Parts Manual

Series 90 100cc

Axial Piston Motor

Service bulletin

Dowel pin change

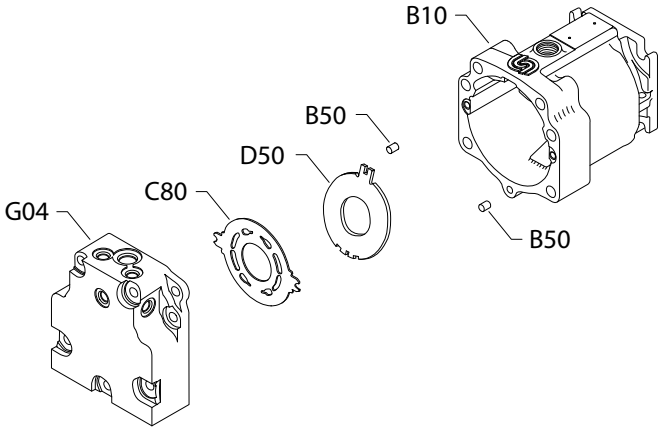
A product change has occurred on Series 90: 75cc and 100cc fixed displacement motors.

The dowel pins (item B50) have increased in diameter from 1/4" to 3/8". With this change, the dowel pin hole diameters in the end cap (item G04), housing (item B10), and the valve plate (item C80) have also changed. In addition, the thrust plate (item D50) in the 100 cc fixed displacement motor has also changed to fit the new housing.

This change creates spare parts non-interchangeability among all of the above mentioned parts. All of the affected parts remain available for the repair of any vintage Series 90 fixed motor. Refer to the date code portion of the serial number on the name plate of the motor being repaired when ordering parts.

Item*	Quantity per motor	75 cc Prior to 88-43	75 cc From 88-43	100 cc Prior to 88-23	100 cc From 88-23
G04 (axial)	1	8100233	8100306	8200123	8200152
G04 (twin)	1	8100232	8100279	8200122	8200151
C80	1	8100095	8100278	8200103	8200134
D50	1	No Change	No Change	8200014	8200167
B50	2	9004800-2512	9004800-3708	9004800-3116	9004800-3708
B10	1	8100252	8100465	8200099	333641

Piston improvement

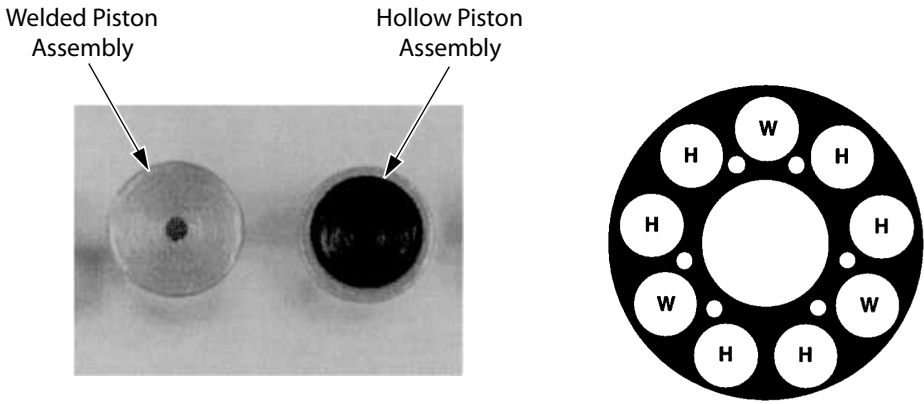
Product Information Bulletin PIB-8801 (March, 1988) announced the incorporation of fabricated (welded) piston assemblies, replacing non-fabricated (hollow) piston assemblies, in the cylinder blocks of all Series 90 pumps and motors. This change increases the overall efficiency of the Series 90 product line.

Since all Series 90 pumps and motors have nine (9) pistons, welded pistons being used to replace hollow pistons during repair **MUST** be install in the cylinder block symmetrically, in multiples of three (3).

Incorporation of adjustable charge relief valve

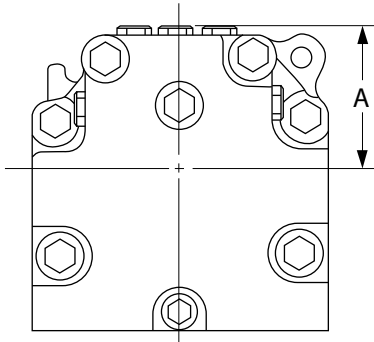
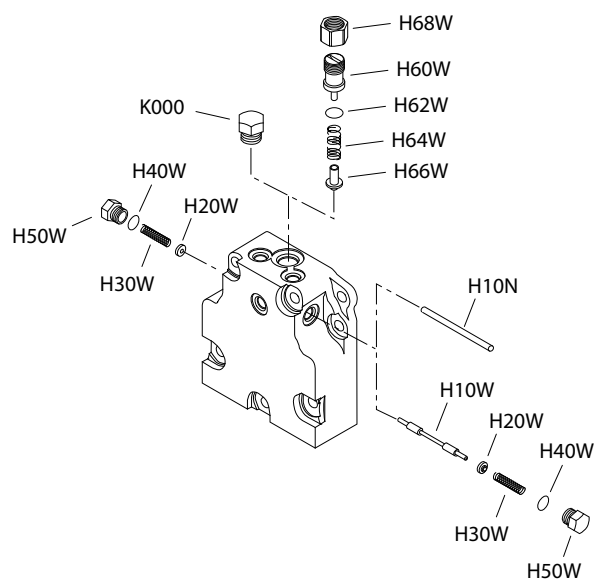
As a product improvement, Danfoss is incorporating an externally adjustable charge relief valve on all series 90 fixed displacement motors. This design replaces the previous shimmed relief valve. The new design valve provides a range of pressure adjustment from 10 to 32 bar.

The diameter of the loop flushing shuttle spool increases from .25" (6.35mm) to .375" (9.53mm) at the same incorporation date as the charge relief valve change.

This is a non-interchangeable change. Adjustable style charge relief valves can not be added to motors manufactured before this incorporation date. Old style end caps, which house the charge relief and loop flushing valves, will not be available as service parts. If new end caps are required, new style charge relief and loop flushing parts must also be installed.

All 100cc motors (96-3xxx) will change at s/n A-90-20-xxxxx

Part number	Description
8000196	Twin port - 55 cc
8000197	Axial port - 55 cc
8100373	Twin port - 75 cc
8100374	Axial port - 75 cc
8200188	Twin port - 100 cc
8200189	Axial port - 100 cc

Charge relief seat

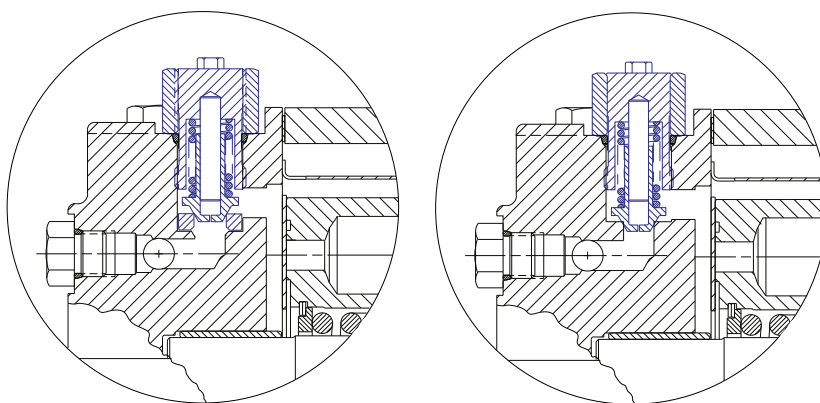
Danfoss has initiated a change to the end caps used on series 90 55cc, 75cc, and 100cc fixed displacement motors, and the series 90 55cc and 75cc variable displacement motors.

Currently, the end caps used on these motors contain a pressed in insert, which serves as a seat for the charge pressure relief valve assembly. The insert was originally introduced to provide a suitable wear surface for the charge pressure relief valve poppet.

Since the original design, a number of changes to the charge pressure relief valve design have reduced the severity of the wear characteristics between the poppet and relief seat. These changes have now made it possible to remove the insert from the end cap assembly. The design of the motor end cap has been modified in a manner that allows the charge relief poppet to seat directly against the casting machined surface.

To aid in identifying and tracking this change, Danfoss has released new end cap part numbers. The new end cap is directly interchangeable with the previous end cap and with adjustable charge pressure relief valve components. The previous end cap part numbers will no longer be available as service parts. Page 2 of this bulletin provides part number cross-reference information.

Change became effective with s/n A-98-34-xxxxx and beyond.

Motor housing change

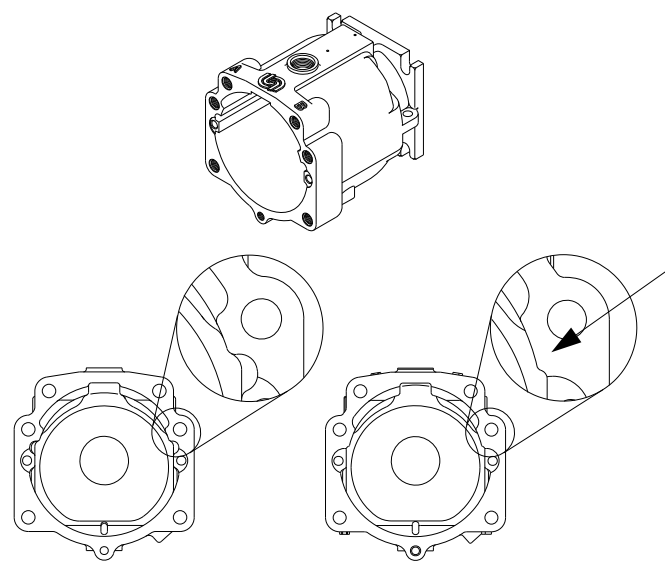
Danfoss has introduced a design change to the motor housings used on all series 90 100cc fixed displacement motors. The housing strength has been increased in the area of the casting ribs, by increasing the size of the rib. This change will reduce the potential for cracking the rib of the housing when tightening the two shorter end cap bolts.

To assist in identifying this change, Danfoss has released a new housing part number. The new housing is completely interchangeable with the previous housing. The previous housing has been obsoleted and is no longer available

Loop flushing spring and spring seat change

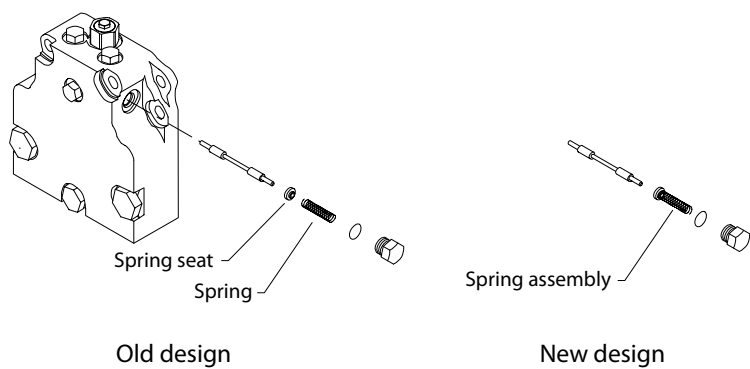
Since the new spring assembly has a high spring rate than the previous spring, this is an interchangeable change only if both springs and spring seats are replaced at the same time. Danfoss has issued a new part number for the spring assembly. The previous spring seat and spring remain valid service parts since they are used on other Danfoss products.

Danfoss Ames, IA production - Change effective at serial number A-02-03-xxxxx.

Danfoss Neumunster, Germany production - Change effective at serial number N-01-08-xxxxx..

Change to end cap gasket material

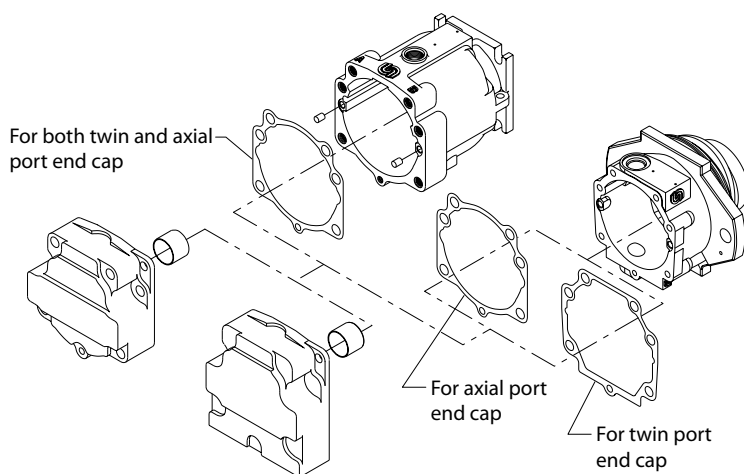
Danfoss Ames, IA production - Change effective at s/n A-01-19-xxxxx.

Danfoss Neumunster, Germany production - Change effective at s/n N-01-19-xxxxx..

Housing change to accept long screws

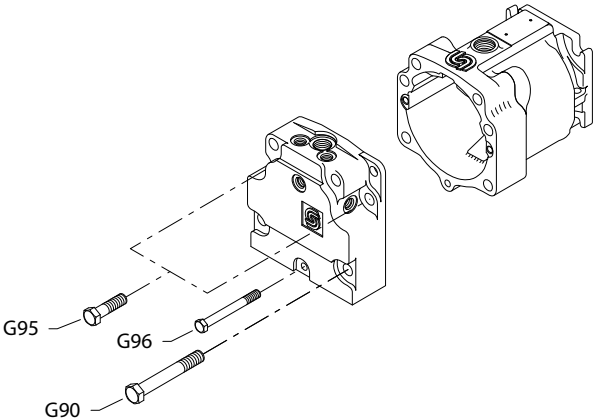
Danfoss has changed the housing used in series 90 100 cc fixed motors. Material was added at the area of the two shorter end cap mounting screws (G95). The hole for these screws is now deeper to accept the longer screw (G90) that is used for the other four large end cap mounting screws. The six larger screws will have the same stretch and therefore the same clamping force for the gasket sealing area. The smaller end cap mounting screw (G96) remains the same. The "old" housing and the short screws will become obsolete and no longer available for service.

Seal change

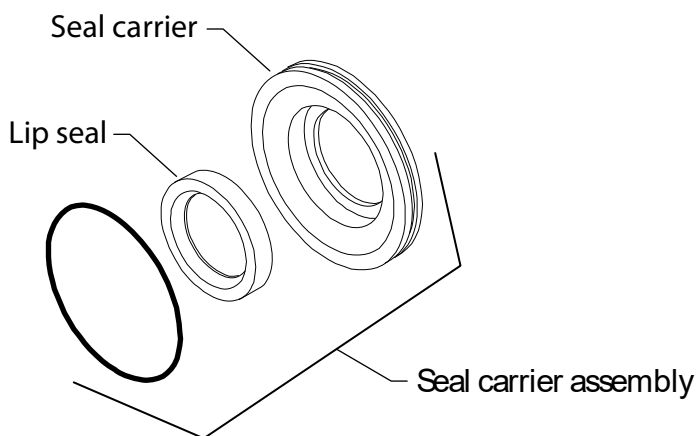
The seal carrier assembly part number has changed to better track this change. The new seal carrier assembly is interchangeable, but the piece parts are not.

This change takes effect at serial number: A-09-02-XXXXX.

- Interchangeable - assembly only, not individual parts
- Use parts in stock
- Order replacement parts
- Revise existing part orders
